POWER-STRUT®

Seismic Bracing Systems

- Seismic Load Specifications
- Load & Horizontal Load Schedules
- Design Tables
- Bracing Channel, Fittings, & Accessories Images
- Through January 2009

Some of the pages in this book are pending approval by OSHPD. They have been signed by the Structural Engineer and have been submitted but are awaiting review. Many of the approvals awaiting review need corrections and for this reason OSHPD is checking what they have approved before they approve new items even though many of those may be corrections to a previous approval.

PAGE
A12

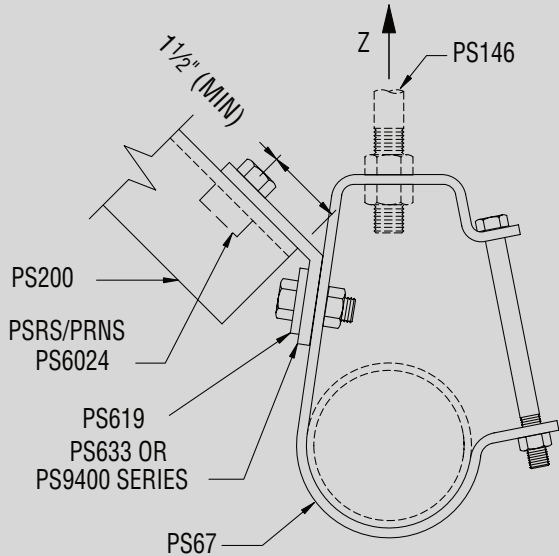
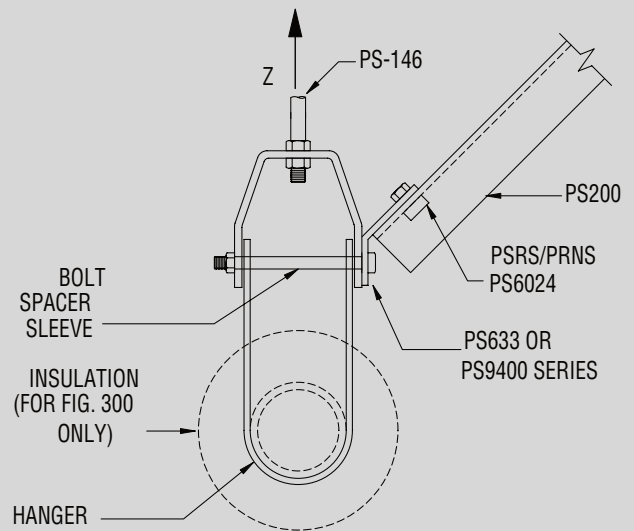
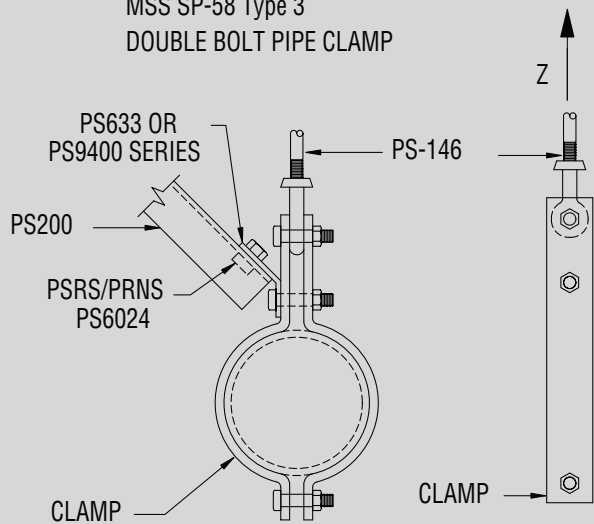
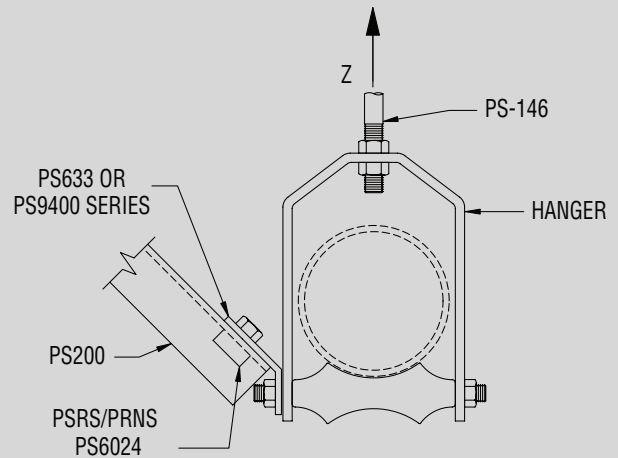
A12 and A13: Changed component names to comply with MSS SP-58 Type numbers

TITLE	
Single Pipe Hanger Brace/Clamp	
PAGE	DATE
A14	04/25/2003

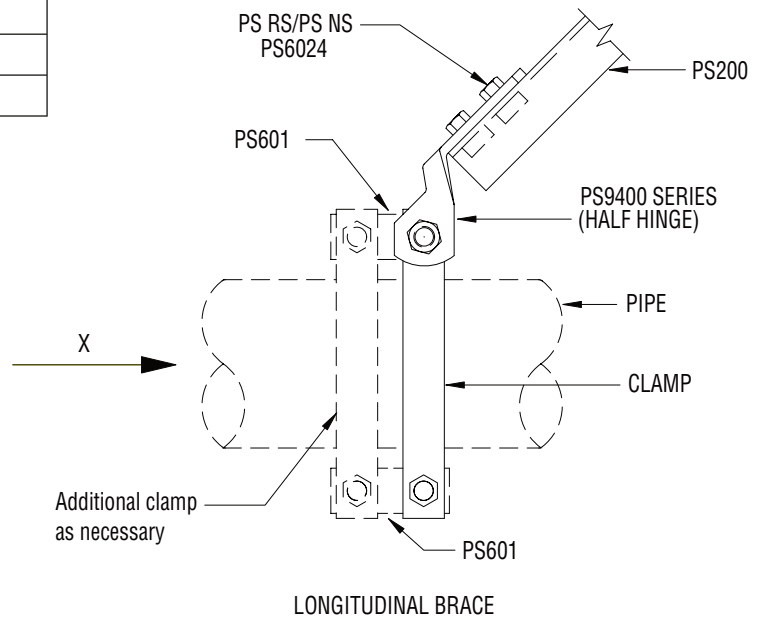
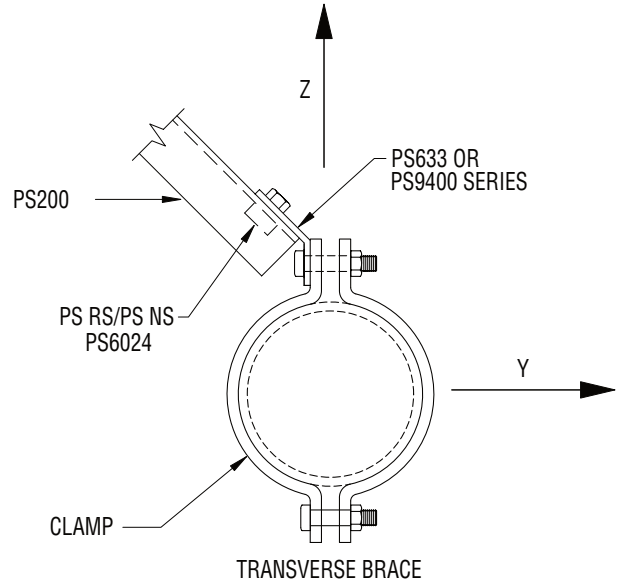
A1 and A14: The OSHPD approved pages may still be rejected by the SEOR as it does not include vertical seismic required by the CBC. The submitted, but not OSHPD approved pages meet the OSHPD requirement and the Code.

PS137 HANGER ROD STIFFENER ASSEMBLY
For 3/4" & 7/8" Rods

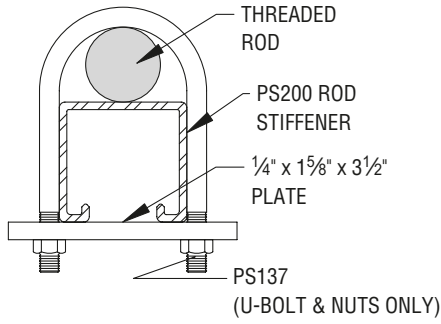
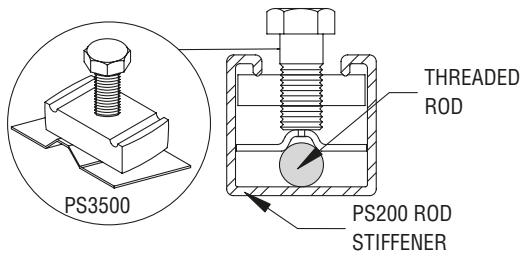
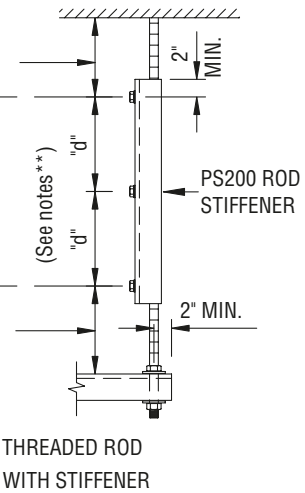
B1: The page added closer rod stiffener spacing where compression loads may exceed $L/r = 200$. This is especially important when using other OSHPD pre-approvals where compression loads have been ignored when using cable for brace material.

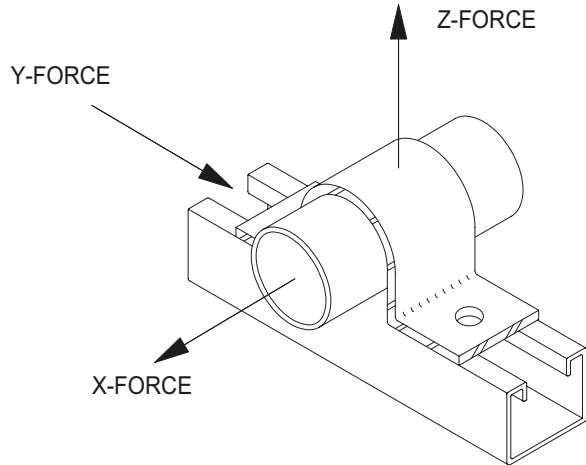
B5 and B6: Allowable loads for pipe clamps used a factor of 5 in order to cover all piping applications in accordance with MSS standards at that time. However, we did not print safety factors used for our products in the approval. Since then there is a proposal to change the standard. And OSHPD has approved these type clamps with a safety factor of 3.5. To convert to a safety factor of 3.5 multiply the approval by 5 and divide by 3.5.

Example: 200 pound rating $\times 5/3.5 = 286$

<p>SUBMITTED</p> <p>OPA-0242, Rev 1</p>	 JOSEPH L. LA BRIE Structural Engineer No. SE 3566 55 E Huntington Dr Suite 277 Arcadia, CA 91006	<p>TITLE</p> <p>One Bolt Steel Lug</p>	
		<p>PAGE</p> <p>B7</p>	<p>DATE</p> <p>04/21/2005</p>

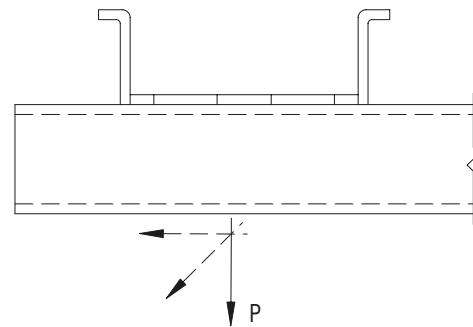
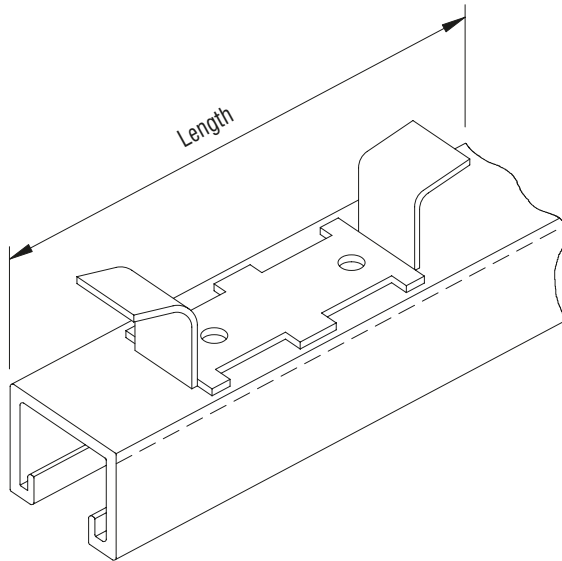
B7: Changed component name to comply with MSS SP-58 Type number

TITLE	
	Brace Pattern Selection	
	PAGE C2	DATE

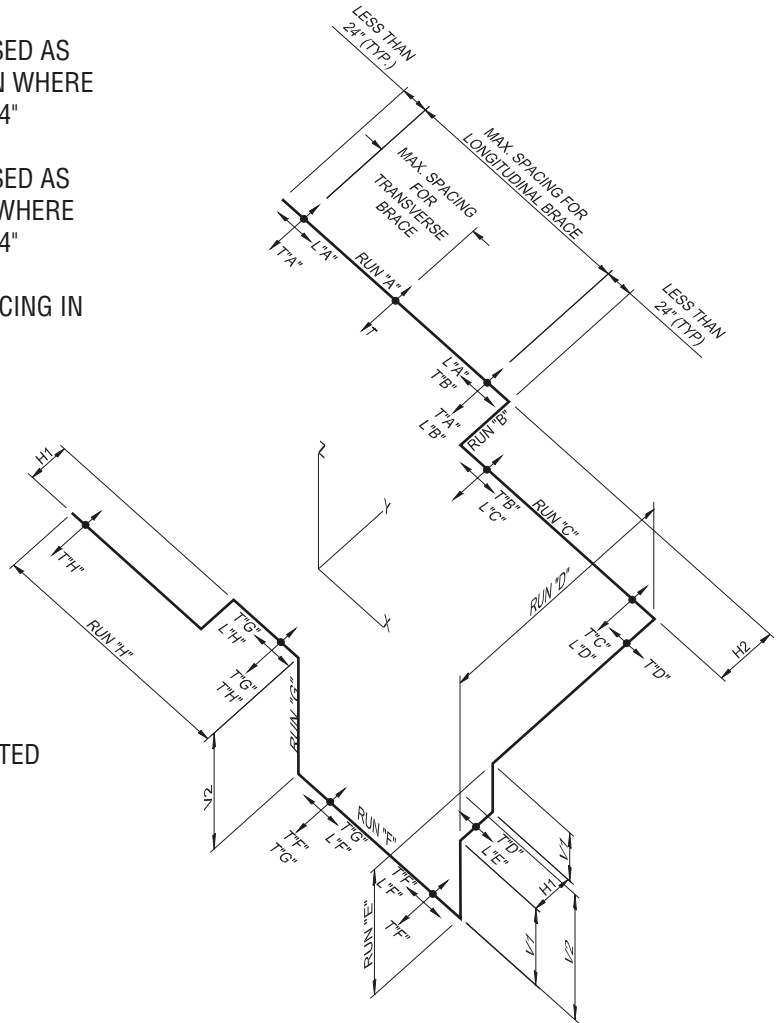
C2: This is somewhat redundant to C1 but includes a layout for the differing brace patterns.
